DRD	
ARCHITECTURE	
INTERIOR DESIGN	
corporate • hospitality • leisure	
DRD Architectural & Interior Design LTD	
The Studio 34 Lime Tree Avenue Retford	
Nottinghamshire DN22 7BA	
t: +44 (0) 1909 768 763	
info@drd-design.co.uk	
CLIENT:	
Craft Union Pub Co	
PROJECT:	
Dog & Partridge	
1 - 3 Wellgate	
Clitheroe, Lancs'	
BB7 2DS	
TITLE:	
existing & proposed	
elevations	
STATUS:	
PLANNING	
DRAWN BY:	
Dave Robinson	
DATE:	
29/07/2022	
SCALE:	
1/100 @ A1	
DRAWING No:	
1900.5	
REV:	
B

proposed front elevation (south facing)

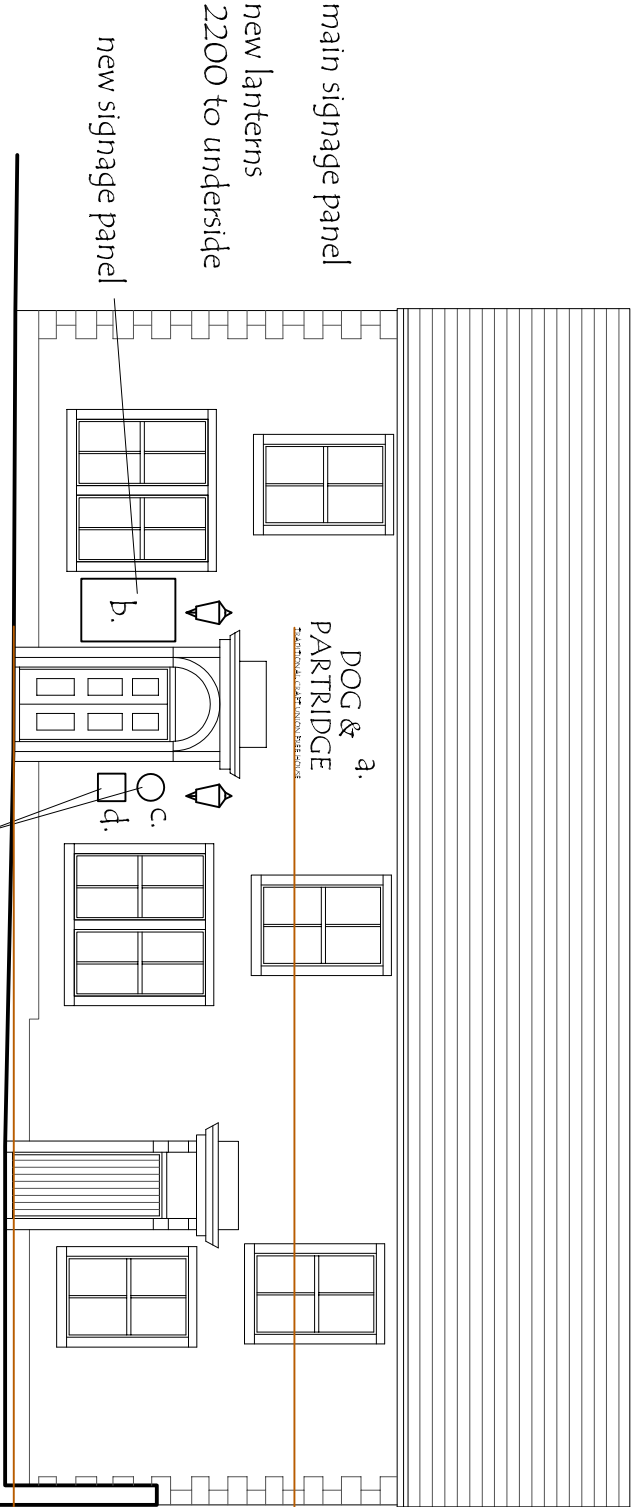
proposed elevations revised to included additional information requested by planning main signage added to front elevation with dimensions + dimensions added to external shelter & porch at rear

proposed rear elevation (north facing)

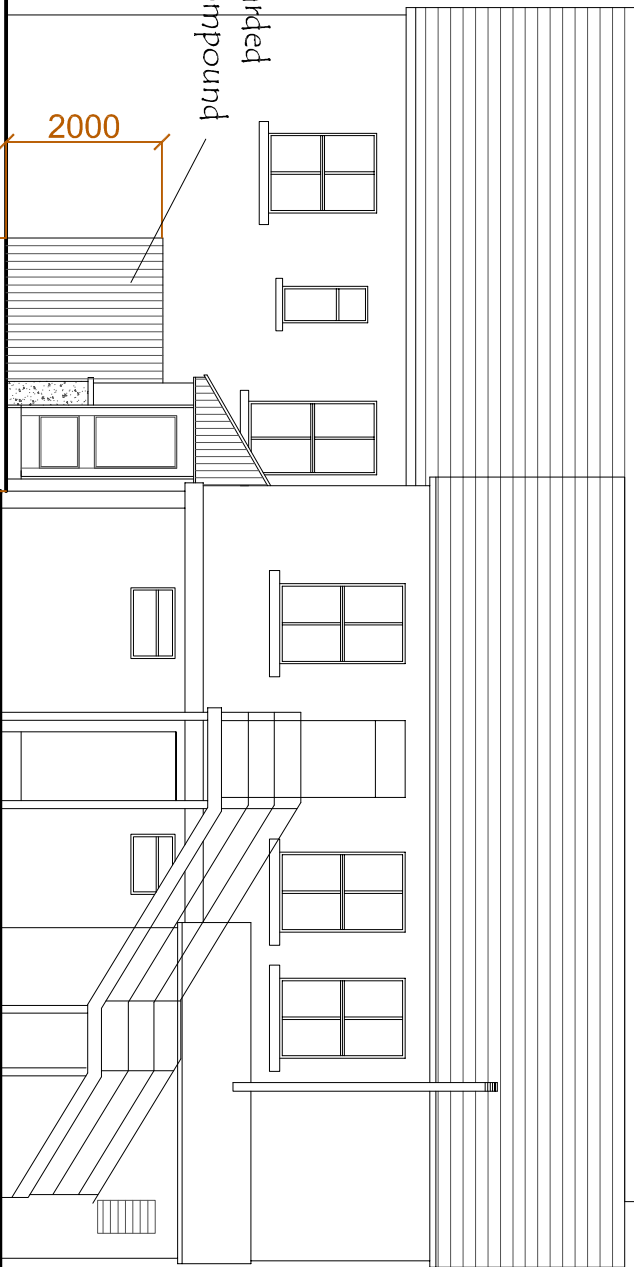
new bin compound indicated on drawing previous timber framed smoking shelter / festoon lighting omitted from drawing
